Errata

SLG46881

CE-GP-018

This document contains the known errata for SLG46881 and the recommended workarounds.

Figure 1: Example Data

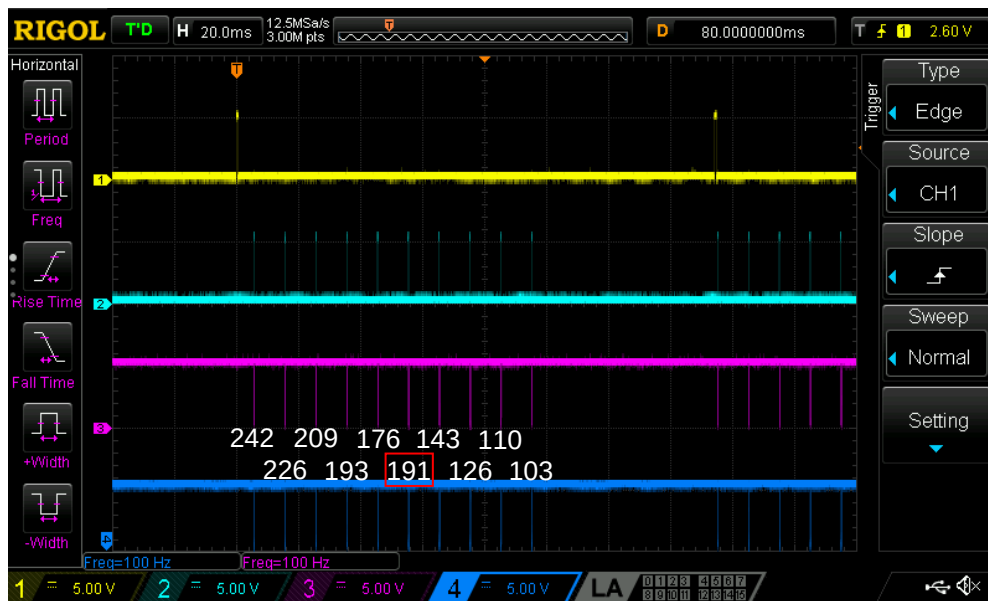
Asynchronous interaction between the CNT/DLY clock input and the I²C latch signal (generated by an I²C read command of the CNT/DLY block's count value) can result in an incorrect I²C data read. The CNT/DLY block will count accurately, but the count value transferred into the block's I²C read register might be loaded incompletely if the I²C latch signal and the clock input occur at about the same time.

The example data capture below shows ten periodic I²C reads of CNT2/DLY2 configured to count down at about 16 clocks per read. The sixth read sample erroneously shows a value greater than that of the fifth. The seventh sample reads as if the previous I²C error never occurred - the difference from the fifth sample (176) to the seventh (143) is 33 clocks or 16 clocks + 17 clocks as expected.

If the possibility of incorrect I²C data reads can't be accommodated for by external software checks, one can guarantee proper operation by stopping the CNT/DLY block's clock during I²C reads through one of the following methods: by disabling the oscillator block, by reconfiguring the CNT/DLY block's clock source, or by gating an external clock using a LUT (Look Up Table) in the signal matrix. After disabling the CNT/DLY block's clock, the count registers can be read without error. Please note that this workaround will add the I²C read and processing time to the counter's overall clock period.

The best workaround depends on the resource constraints of the application. If the oscillator block doesn't clock other logic elements within the design, a matrix output can be used to manually power down the oscillators for the I²C read. When the CNT/DLY block's clock source is routed internally from the oscillator block, I²C commands can temporarily reconfigure the CNT/DLY block's clock source registers to select "Ext. CLK. (From Matrix)." This action will disable the clock by connecting it to ground. If the CNT/DLY block is clocked from the signal matrix, the LUT can be used to gate the clock during the I²C read.

Figure 2: Testing Diagram

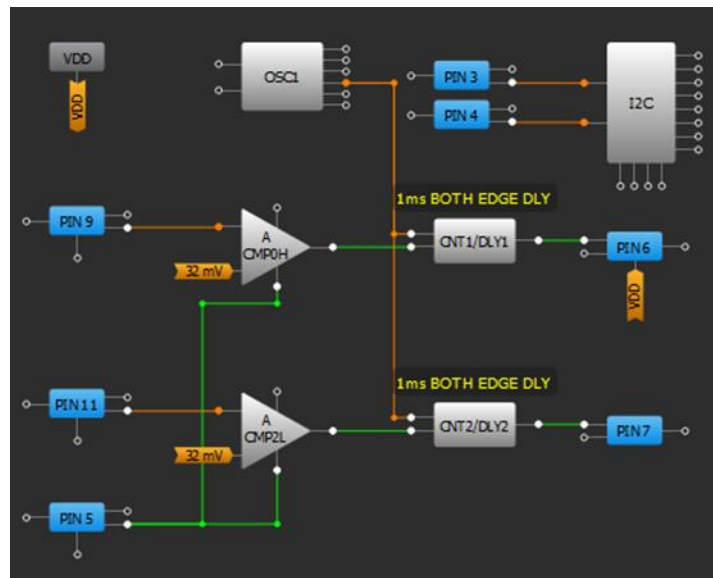
There is some noise coupling from the Vrefs of high-speed ACMPs to the low-power bandgap (BG) while the high-speed ACMPs Vref is turning on and off.

There is no issue with manually powering up the low-speed ACMPs. If you are manually powering up the high-speed ACMPs via the “PWR UP” connector, you should add a 1 ms delay to the output of all of the ACMPs used in the design.

Figure 3: Voltage Reference Block Diagram

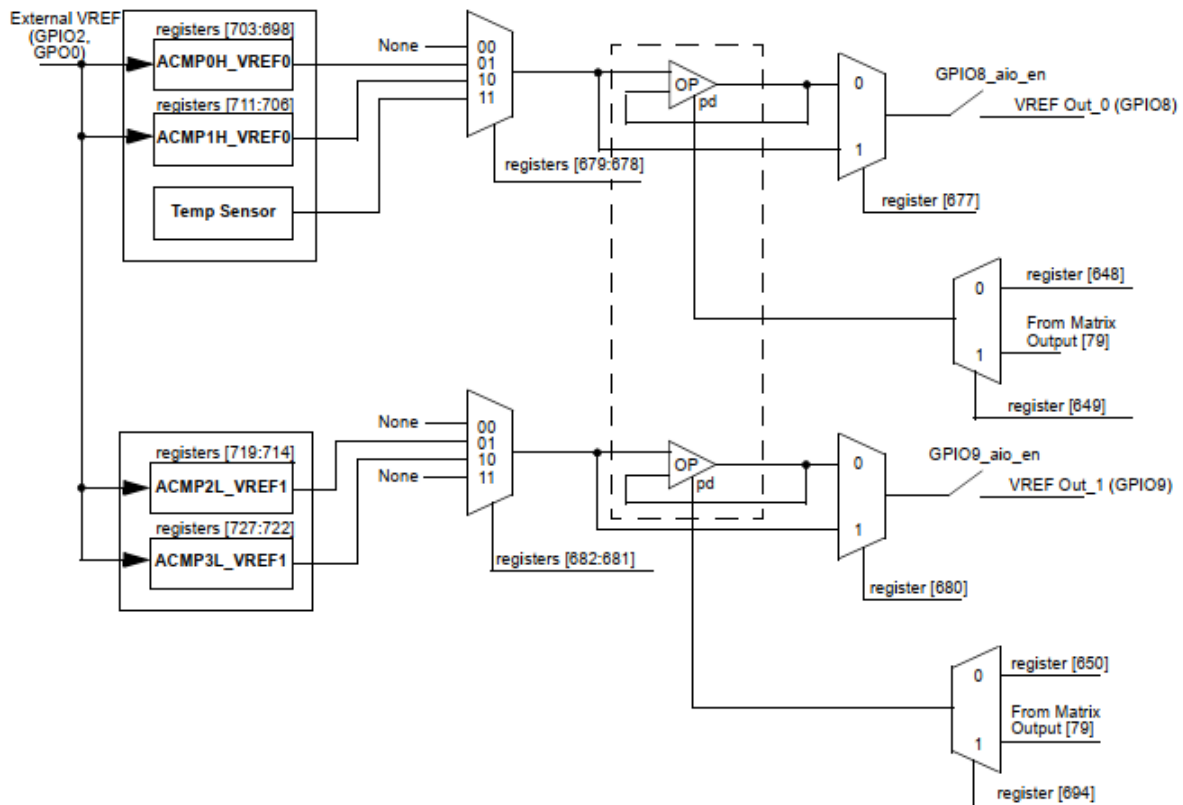
For systems where $V_{DD} = 2.5 \text{ V}$, the Vref output buffer will be unstable if the output voltage is around $0.5 \times V_{DD}$.

For a system where $V_{DD} = 2.5 \text{ V}$, bypass the buffer if the output voltage of the Vref buffer is within $(0.5 \times V_{DD}) \pm 0.4$. Check the Vref section of the device datasheet to see which registers need to be modified.

Figure 4: GreenPAK Input Structure Test Schematic

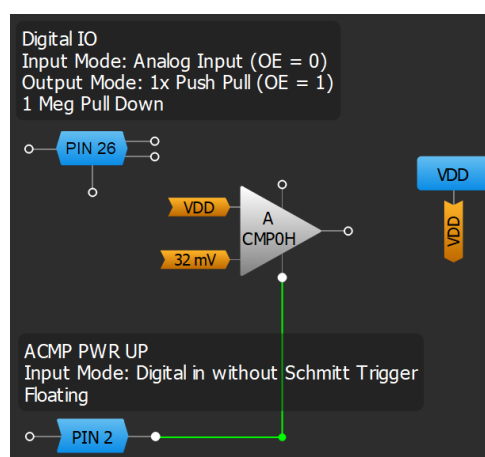
Figure 4 shows the GreenPAK configured with GPIO10 as a Digital IO with a 1 MΩ pull-down resistor. Since the OE pin is connected to 0 V, this pin is acting as an "Analog IO." As seen in [Error! Reference source not found. Table 2](#), GPIO10 and V_{DD} are both input options for ACMP0H. In this example, GPIO00 is being used as a digital input to enable and disable the ACMP.

There is no workaround for this behavior. With this in mind, the GPIOs should not be used as digital IOs (with “Input mode” set to Analog input) or as digital outputs (with “Output mode” set to 1/2/4x 3-State Output) if the respective ACMP is enabled and connected to another input source. Under these same ACMP conditions, the system designer should be aware that the GPOs listed in [Table 2](#) will be connected to their respective ACMP IN+ sources if configured as “PIN not used.”

Figure 5: ACMP Input Structure Behavior

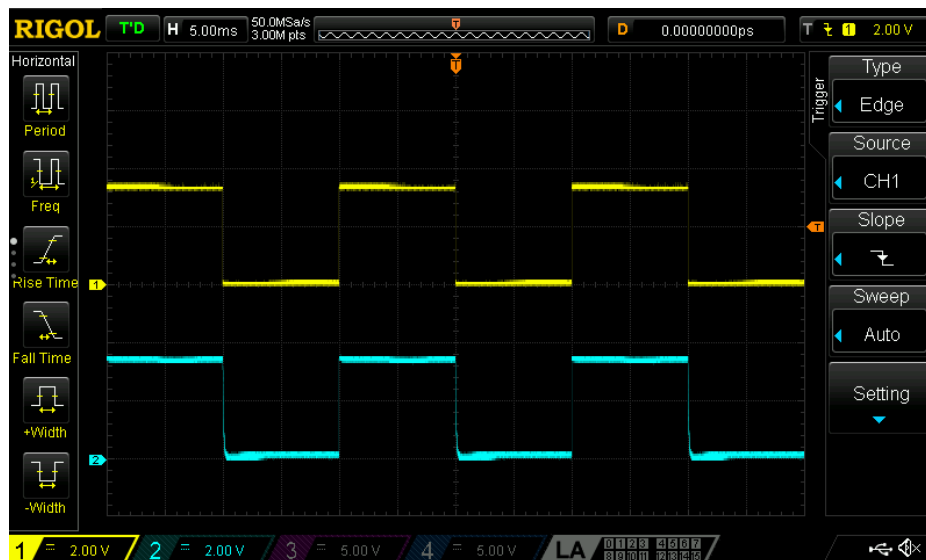
Figure 5 shows that GPIO10 in analog input mode is pulled HIGH by the V_{DD} signal whenever the ACMP is enabled despite having an internal pull down resistor. This behavior is caused by an internal connection between V_{DD} and GPIO10. Similar behavior can be reproduced when one ACMP's IN+ port is connected to another ACMP's IN+ port.

Figure 6: Testing Design

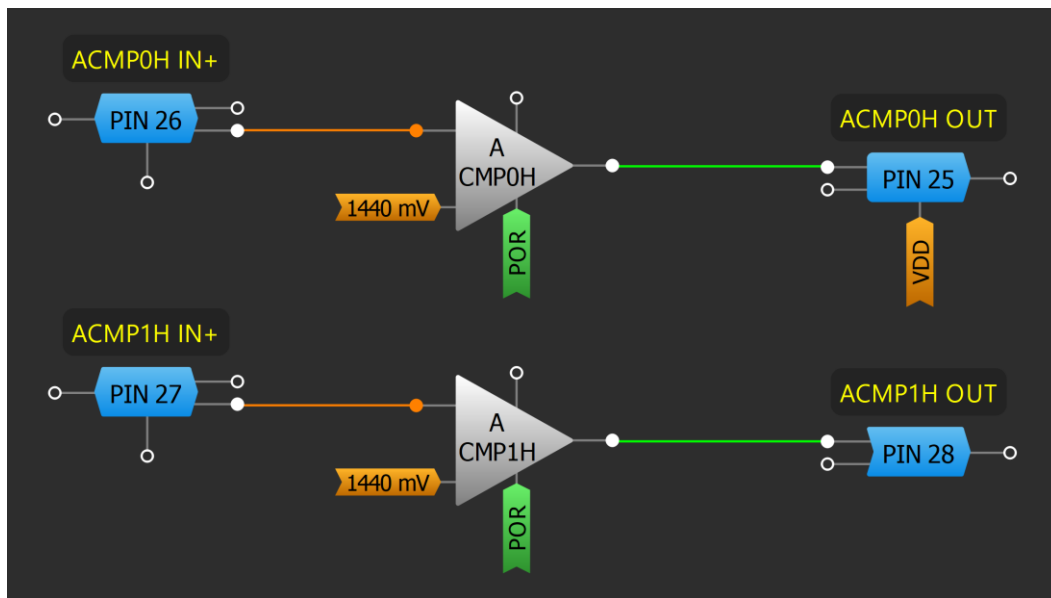
If using ACMPxH in with 32 mV or 64 mV hysteresis, ACMPxH output could be glitching when ACMPxH positive input (IN+) is close to the negative input (IN-). It can happen when $V_{DD} = 4.6$ V or higher and Vref is in a range from 1.312 V to 2.016 V for 32 mV hysteresis, and Vref is in a range from 1.312 V to 1.696 V for 64 mV hysteresis.

1. Use the deglitch filter connected to the ACMPxH output.
2. Avoid conditions described in paragraph 3.6.2.

Figure 7: ACMP Output during Glitching

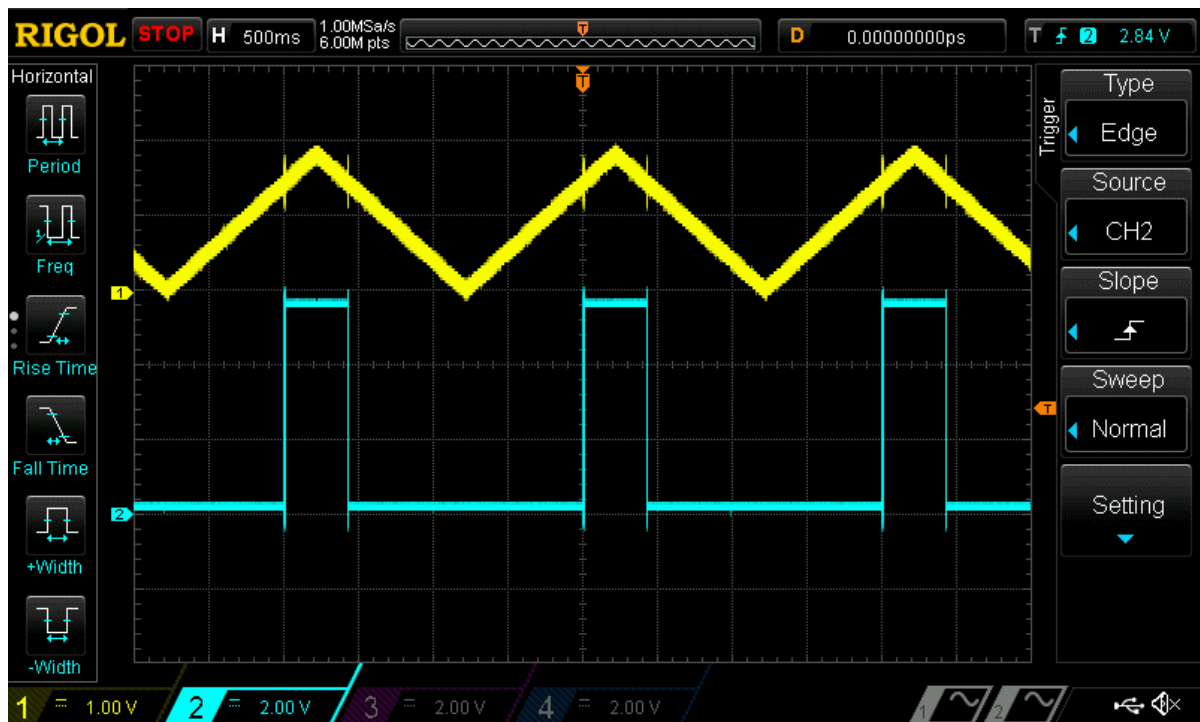
- Channel (yellow/top line) - PIN#26 (ACMP0H IN+)
- Channel (light blue/top line) - PIN#25 (ACMP0H OUT)
1. Waveform at Vref = 1440 mV, hysteresis is equal to 32 mV.

Figure 8: Zoomed ACMP Output during Glitching

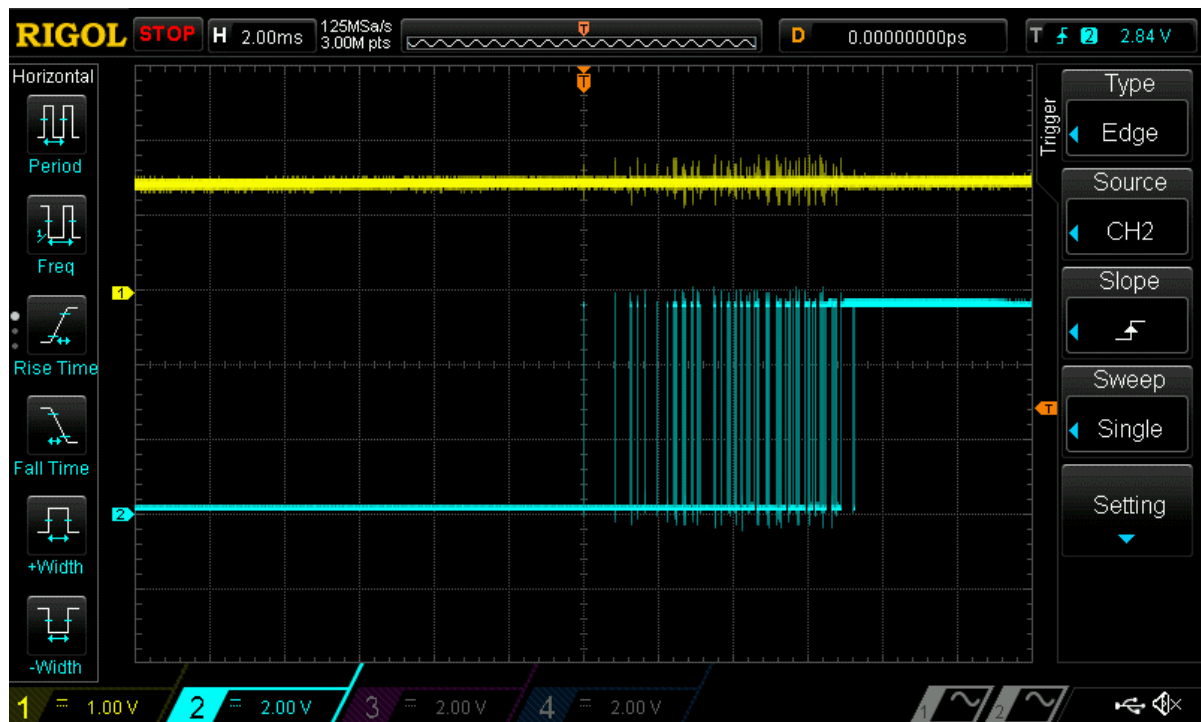
2. Waveform at Vref = 1440 mV, hysteresis is equal to 32 mV (zoomed rising edge).
